Knit Radix Limited (Extension)

12 September 2024

Observation 1: Discrepancy and missing information in the provided drawing (Shed-1).

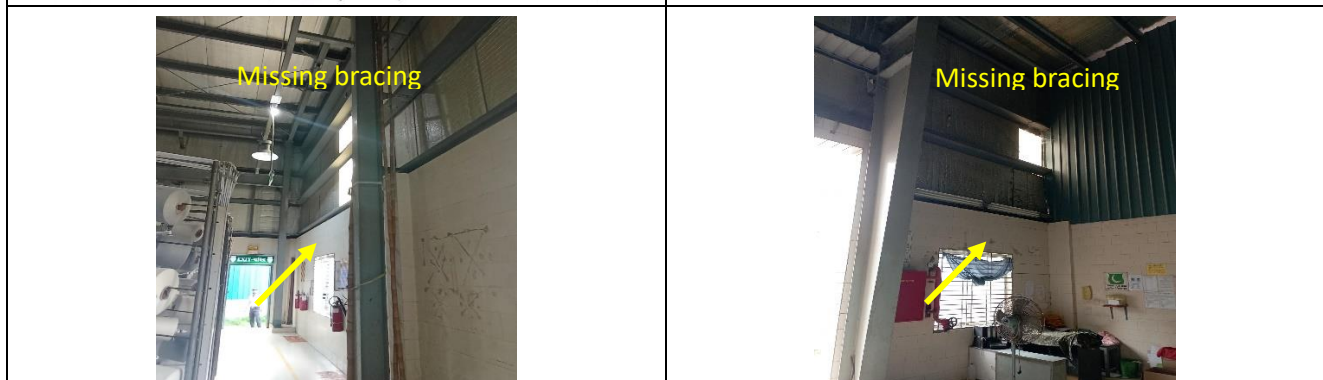
Description: Vertical bracing was missing at marked locations therefore bracing system was not found symmetric. Besides, RC details of the substructure were missing from the provided drawing. The building engineer is required to update the as-built drawings as per 1.9.1 BNBC (Part 6). Also, check the lateral stability of the structure and propose a remediation plan.
